MEMORANDUM

From: Chief Officer Environment & Technical **To:** Chief Officer Planning & Regulatory
Our Ref: PR/DC/P/2019/0479 **Your Ref:** SEH/P/2019/0479
Date: 10th July 2019

Location: O. S Grid Ref: 359 519 Land West of Wrexham Golf Club, Holt Road, Llan y Pwll Wrexham.

Development: Application for approval of details reserved by conditions imposed under Planning Permission P/2018/1081:-

Drg. No. 10957 / SK / 001 Rev B

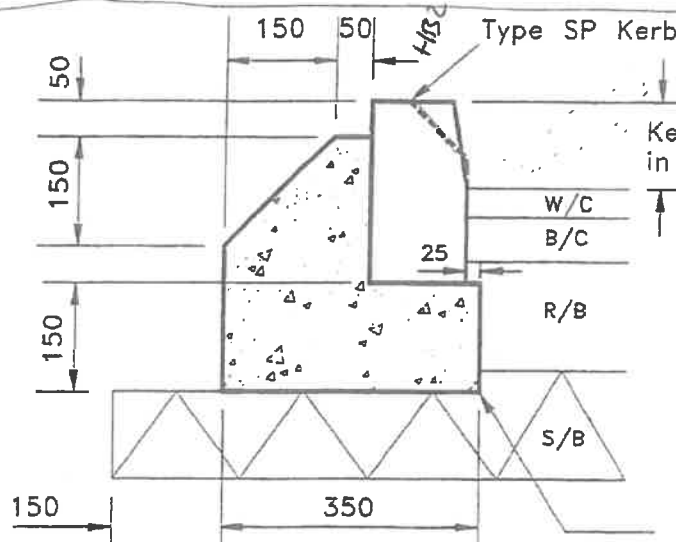
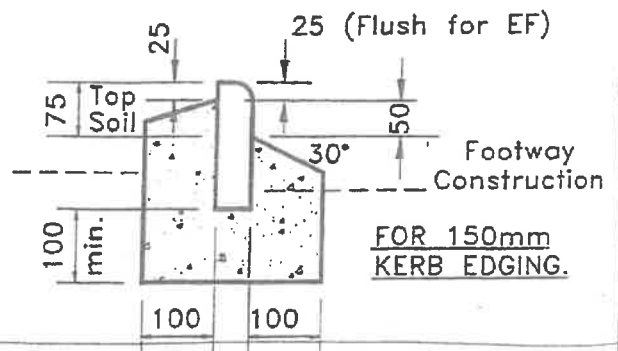
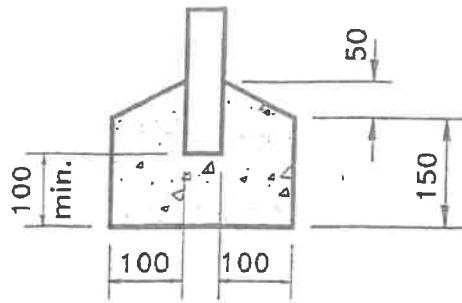
I assume our Public Rights of Way Section will be consulted on this matter.
